# UNITED STATES PATENT AND TRADEMARK OFFICE

APPLICATION NO.	FILING DATE	FIRST NAMED INVENTOR	ATTORNEY DOCKET NO.	CONFIRMATION NO.
10/587,153	07/25/2006	Josef Artelsmair	ARTELSMAIR ET AL 8 PCT	4970
25889	7590	04/13/2011	EXAMINER	
COLLARD & ROE, P.C. 1077 NORTHERN BOULEVARD ROSLYN, NY 11576			DANG, KET D	
			ART UNIT	PAPER NUMBER
			3742	
			MAIL DATE	DELIVERY MODE
			04/13/2011	PAPER

<b>Office Action Summary</b>	<b>Application No.</b> 10/587,153	<b>Applicant(s)</b> ARTELSMAIR ET AL.	
	<b>Examiner</b> KET D. DANG	<b>Art Unit</b> 3742

## **DETAILED ACTION**

**Fig. 3A**

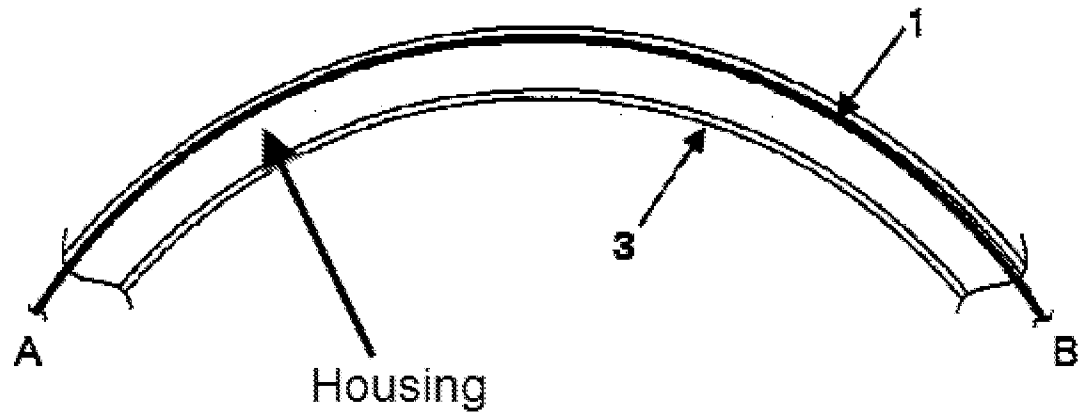
Regarding claim 6, Mukai et al. discloses a welding wire storage device for a welding system (see figure 1) comprising: a housing 3 (fig. 3A) (see figures 3A below for

the indication of a housing) having a free space, a first end region 5 (fig. 1) and a second end region 6 (fig. 1) opposite the first end region (para. 0050-0051); a welding wire 1 (fig. 1) arcuately arranged to lie freely in the free space of the housing; a guide element on the second end region 6 (fig. 1) (para. 0020); and first 5 (fig. 1) and second 6 (fig. 1) coupling mechanisms arranged on the housing (para. 0020, 0021, 0046-0047).

With respect to claim 3, Mukai et al. discloses wherein elements for delimiting maximum deflection of the welding wire 1 are arranged in the housing 3 (fig. 3A) (para. 0019, 0031).

With respect to claim 5, Mukai et al. discloses wherein the housing (see fig. 3A below) is arranged between a welding apparatus or wire feeder 2 (fig. 1) and a welding torch 4 (fig. 1), wherein a hose pack 3 (fig. 1) is arranged directly, without interruption, between the welding apparatus or wire feeder and the welding torch, and wherein the wire core is interrupted in the housing 3 (fig. 3A) (para. 0012).
